A meeting of the **ARGYLL AND BUTE LOCAL REVIEW BODY** will be held in the **COUNCIL CHAMBERS, KILMORY, LOCHGILPHEAD** on **WEDNESDAY, 21 JANUARY 2015** at **10:00 AM**, which you are requested to attend.

1. **APOLOGIES FOR ABSENCE**
2. **DECLARATIONS OF INTEREST (IF ANY)**
3. **CONSIDER NOTICE OF REVIEW REQUEST: LAND WEST OF SCARPAGH, HILLSIDE, BOWMORE, ISLAY (REF:14/0012/LRB)**
 3. (a) Notice of Review and Supporting Documentation (Pages 1 - 14)
 3. (b) Comments from Interested Parties (Pages 15 - 42)

**REFUSAL OF PLANNING PERMISSION FOR THE
ERECTION OF A DWELLINGHOUSE, INSTALLATION
OF SEWAGE TREATMENT PLANT AND FORMATION
OF A NEW VEHICULAR ACCESS RELATIVE TO
PLANNING APPLICATION REFERENCE 14/00031/PP**

Reference No: 14/00031/PP
Planning Hierarchy: Local
Applicant: Mr Donald Baker
Proposal: Erection of dwellinghouse, installation of sewage treatment plant and formation of new vehicular access. (As amended by plan received 27th February 2014)

Figure 1 – Outtake from Argyll and Bute Council Local Plan 2009 (Bowmore).

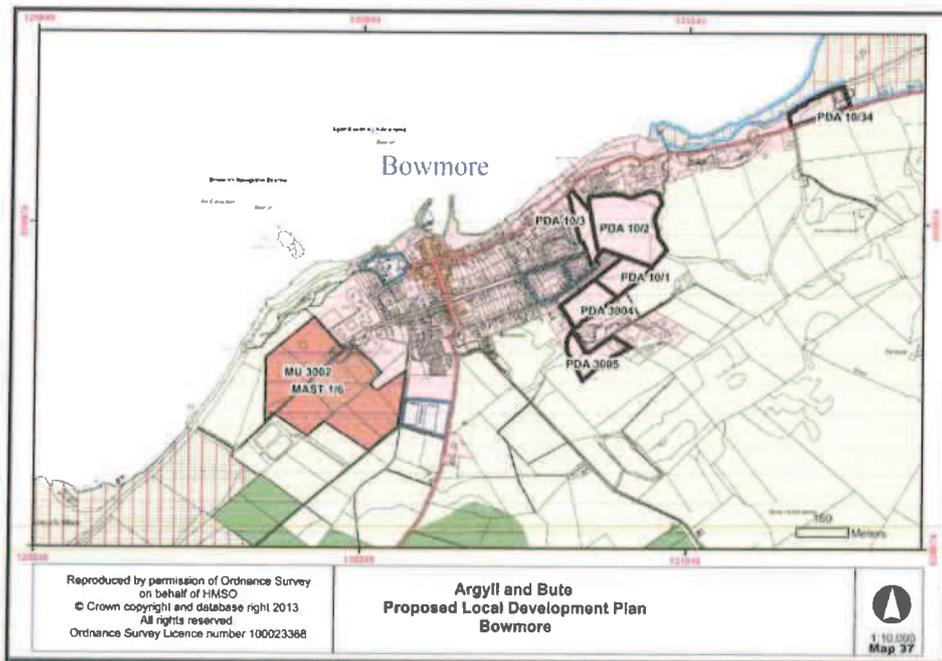
It is true however that within the proposed local plans this area is designated as Potential Development Area 3005 and this does state that this area will be used for low density housing with 25% Affordability. But it is my understanding that this has not, as yet, been approved but is being given material consideration when approving planning applications at the moment. Both the current and proposed local plan maps can be seen from Figures 1 and 2.

- It is true however that within the proposed local plans this area is designated as Potential Development Area 3005 and this does state that this area will be used for low density housing with 25% affordability. But it is my understanding that this has not, as yet, been approved but is being given material consideration when approving planning applications at the moment.

Comment: The emerging Local Development Plan (LDP) is at an advanced stage having been through extensive public consultation and approval by Members. It is estimated that member's permission to adopt the LDP will be sought in January 2015 with adoption following up to four months after.
